PCD File No. PPR-22-012

MERIDIAN SERVICE METROPOLITAN DISTRICT  
WATER TREATMENT PLANT EXPANSION  
GRADING & EROSION CONTROL NOTES

100% DESIGN

C8

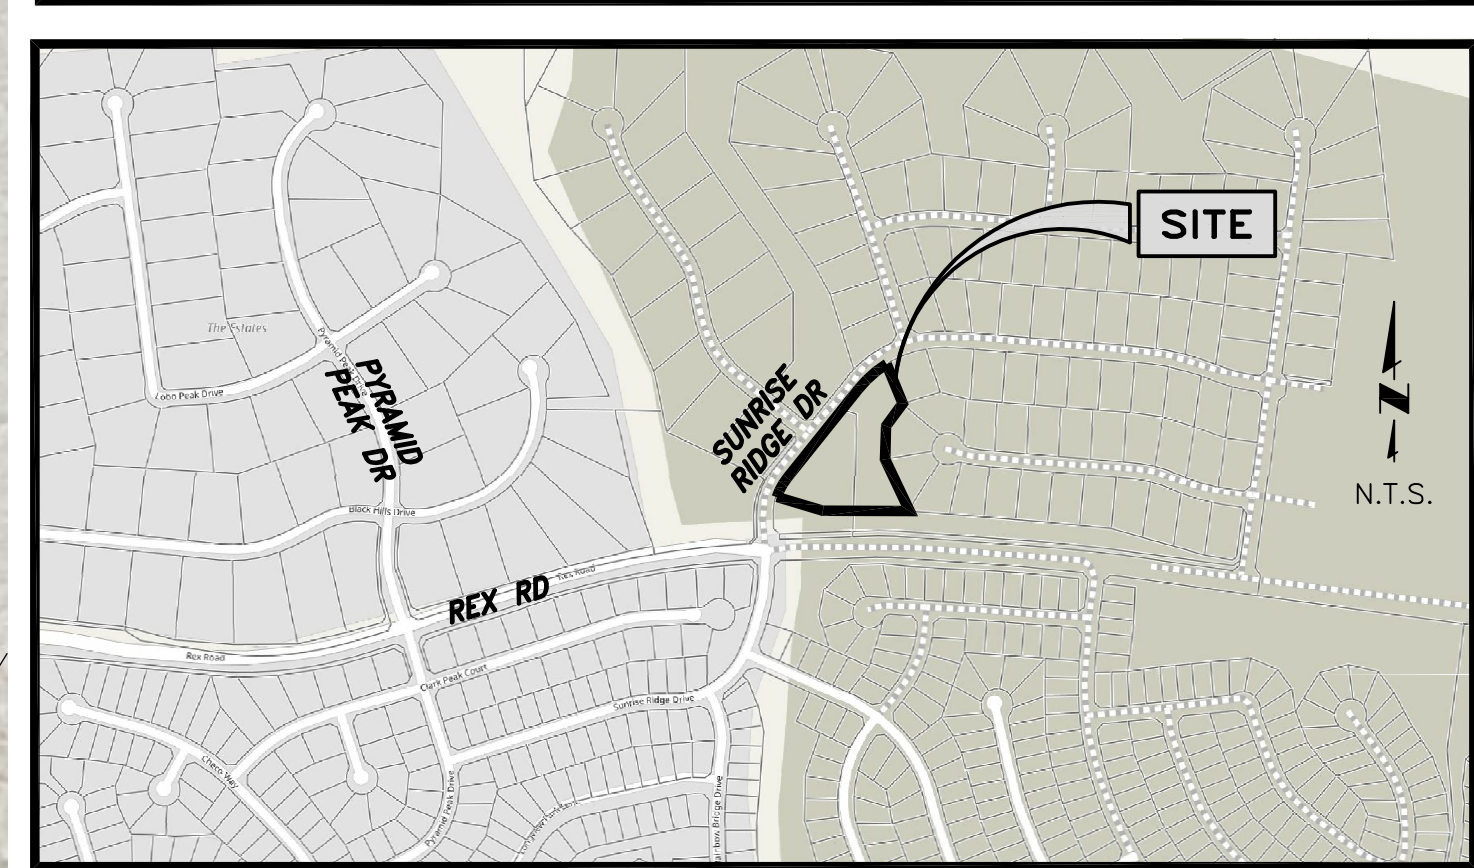
Provide a cover sheet.  
Move the signature blocks to the cover sheet.  
Cover sheet to include the vicinity map, points of contact, sheet index.
